Re: Revised Water Tower Location - Lecompton, KS

RE: Environmental Review Comments - Lecompton, KS Water Tower Location
Revision Grant No. 08-PF-806

47
SE/4
Sec. 3
T. 12S.
R. 18E.

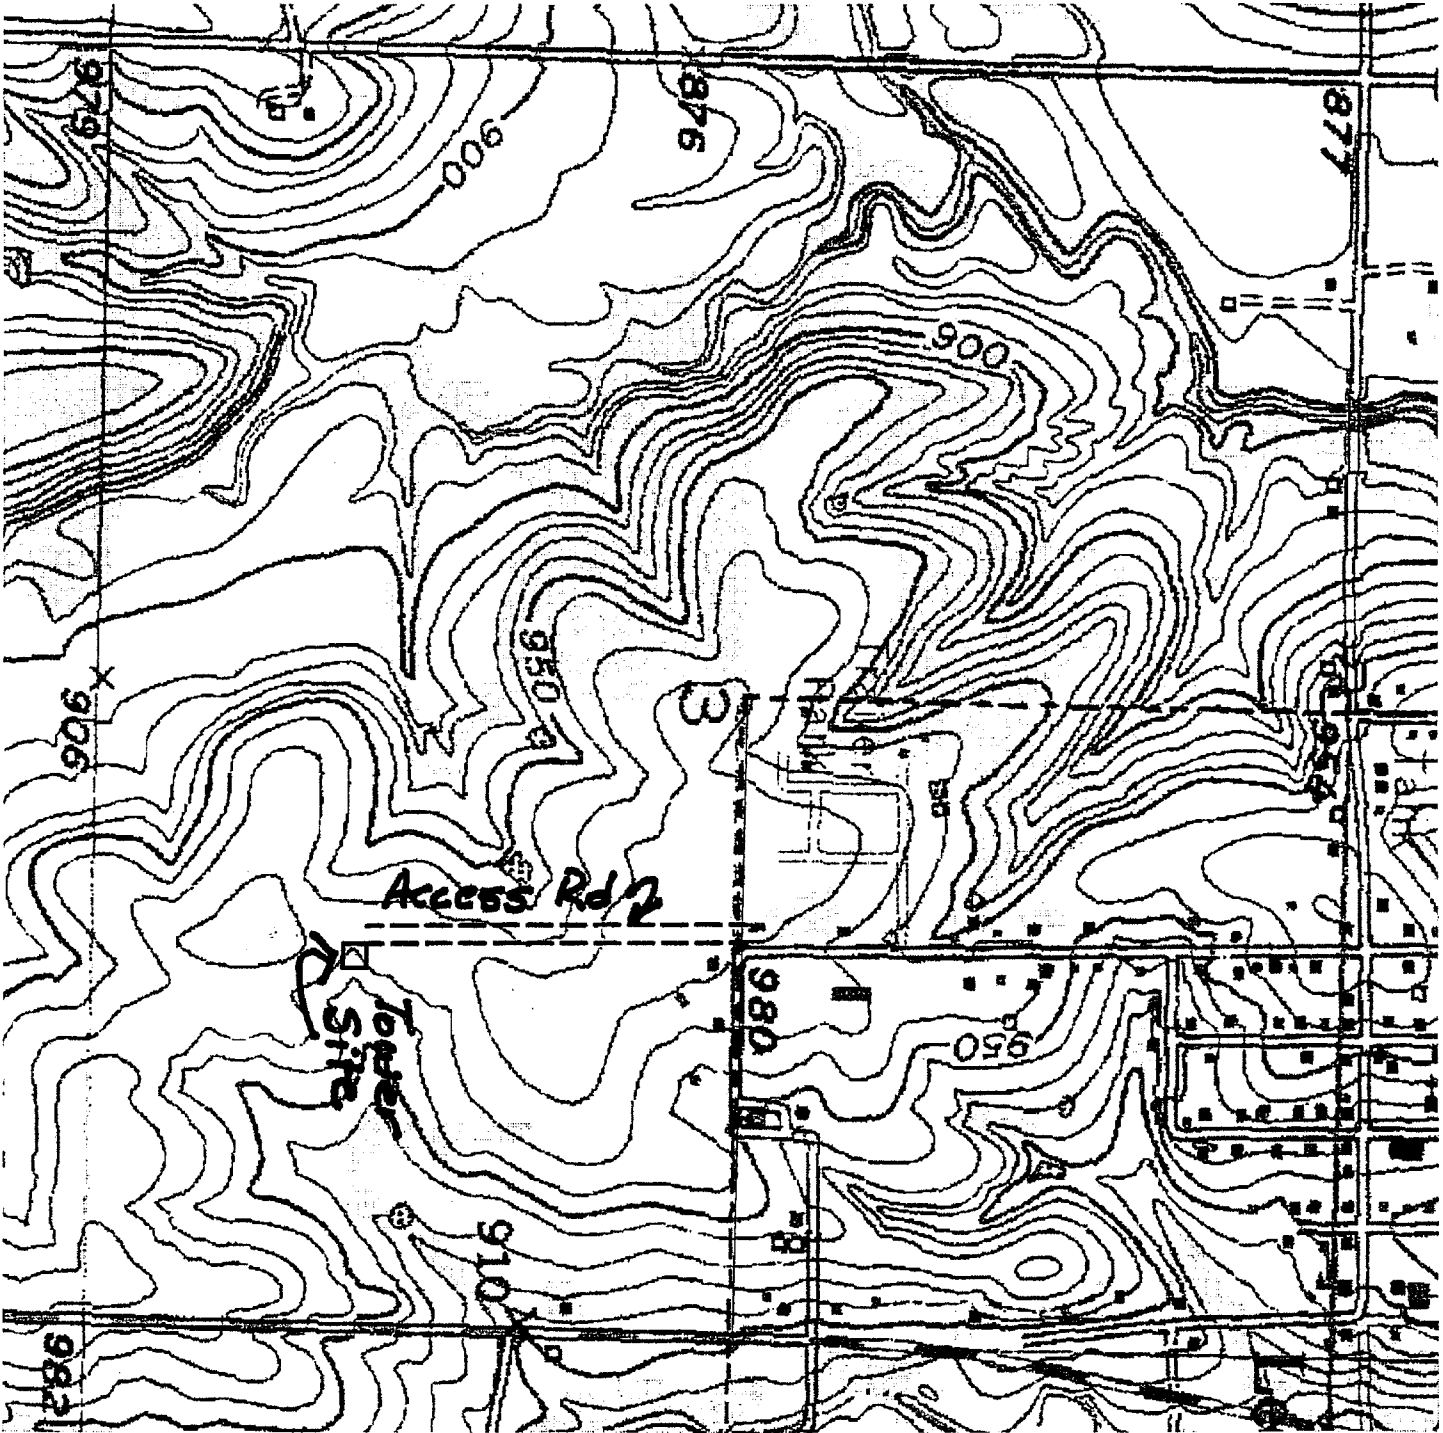
A review of regional geologic information along with a topographic map provided by Governmental Assistance Services indicates that there are no unduly adverse geologic conditions that should affect the project and clearance of the project should be granted. However, considering the potentially large bearing loads associated with the project, the applicant should evaluate site-specific conditions with a geotechnical investigation. A standardized request for environmental comments form was not included with the submittal; therefore, this letter serves as the completed KGS review and response.
